Non-LOCA Release Fractions Feedback

Feedback on Non-LOCA Release Fractions - Proposed PWR Non-LOCA Power Envelope

Proposed changes to Section C, RG 1.183 R1

BWR Rod Power History - Range of Applicability
(Peak Power -15.0 kW/ft BWR (10x10))

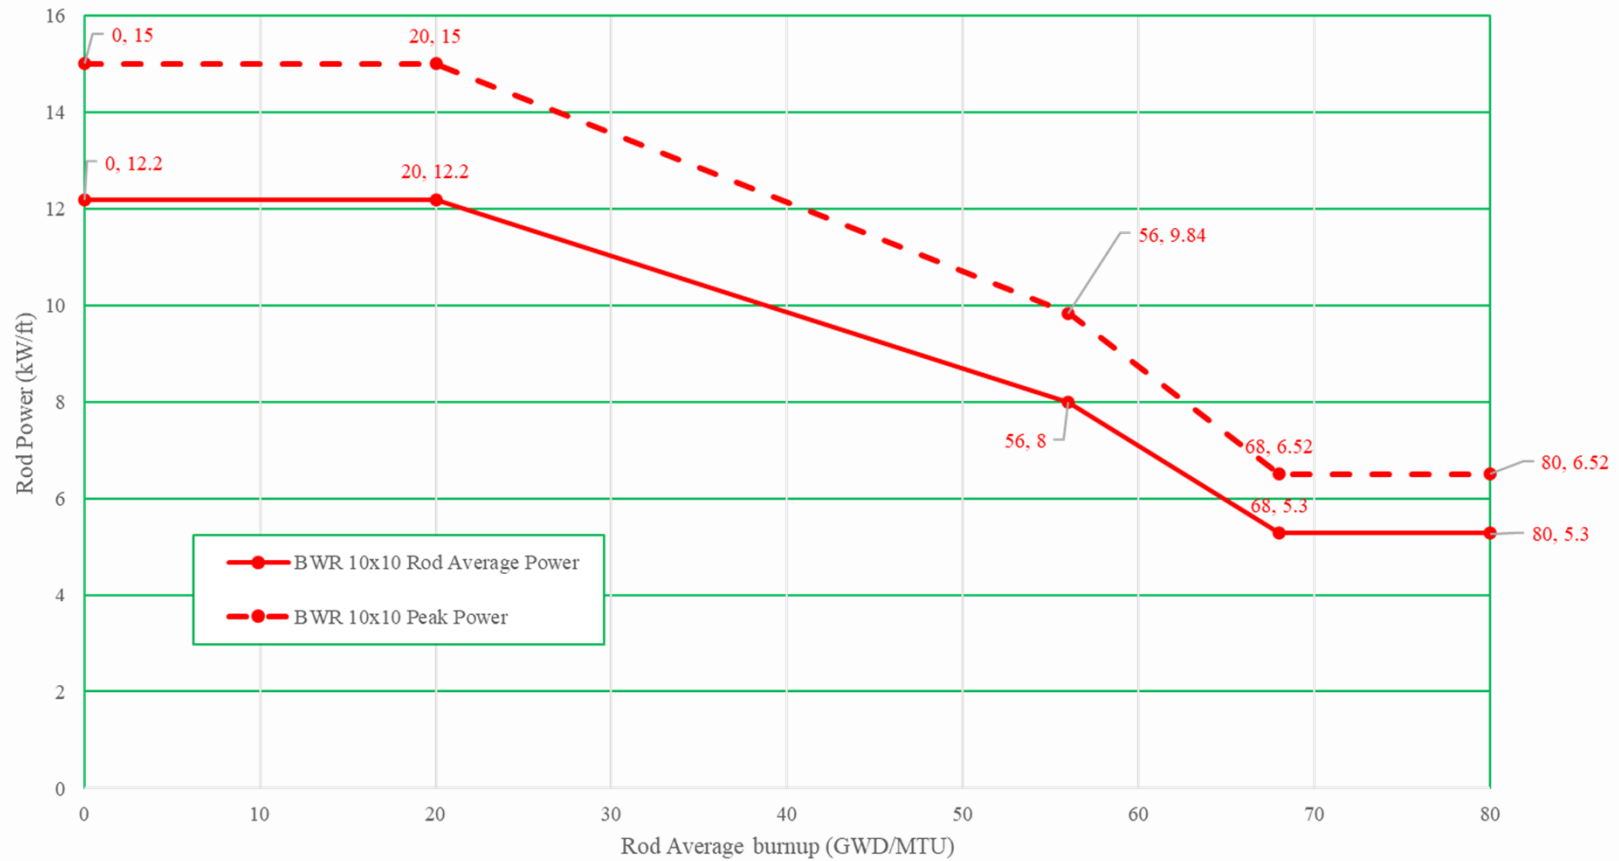
Feedback on Non-LOCA Release Fractions - Proposed BWR Non-LOCA power envelope
